STAFF REPORT: SEPTEMBER 11, 2024, REGULAR MEETING PREPARED BY: T. BOSCARINO
APPLICATION NUMBER: HDC2024-00433
ADDRESS: 1710 VAN DYKE (ALSO KNOWN AS 8005-8025 ST. PAUL)
HISTORIC DISTRICT: WEST VILLAGE
APPLICANT: BRIAN REBAIN, KRAEMER DESIGN GROUP
PROPERTY OWNER: 1710 VAN DYKE LLC
DATE OF PROVISIONALLY COMPLETE APPLICATION: AUGUST 2, 2024
DATE OF STAFF SITE VISIT: AUGUST 24, 2024

SCOPE: ALTER ROOF

Sketch showing proposed repair and replacement areas. Note that the proposed work would approximately double the extent of the area currently finished with asphalt shingles, from about 15% of the total area to about 30%. Image from application materials.

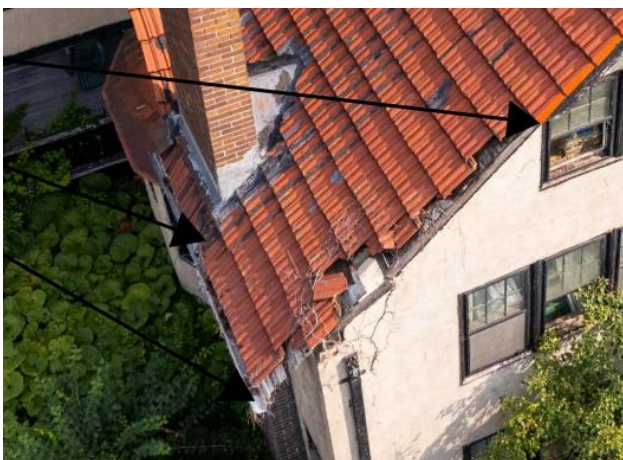
- As the proposed scope would decrease the area of clay tile and increase the area of asphalt shingles, the proposed work would constitute, in part, the replacement of tile with asphalt. The Secretary of the Interior’s Standards for Rehabilitation, namely Standard #6, direct “deteriorated historic features shall be repaired rather than replaced. Where the severity of deterioration requires replacement of a distinctive feature, the new feature shall match the old in design, color, texture, and other visual qualities, and where possible, materials. Replacement of a missing feature shall be substantiated by documentary, physical, or pictorial evidence.”
- *Preservation Briefs: The Preservation and Repair of Historic Clay Tile Roofs* (National Park Service, 1993) provides the following guidance:

- Staff does not consider the use of asphalt shingles on this building to be appropriate, due to the following considerations:
 - Standard #6, quoted above, suggests that damaged areas of clay tile should be replaced with matching materials.
 - Asphalt shingles, in general, are not an appropriate intervention for this particular building due to its Mission-influenced style and the highly distinctive nature of the existing tiles.
- The application scope notes that some “specialty tiles” may need to be replaced, but it does not specify a particular product for replacement other than to state that the tiles “will be evaluated for size and shape once removed.”

- *Undamaged clay tiles will be salvaged and reused to the maximum extent possible, subject to review and approval by staff.*
- *New clay tile will match the historic clay tile as closely as possible, subject to review and approval by staff.*
- *Asphalt shingles will not be used.*
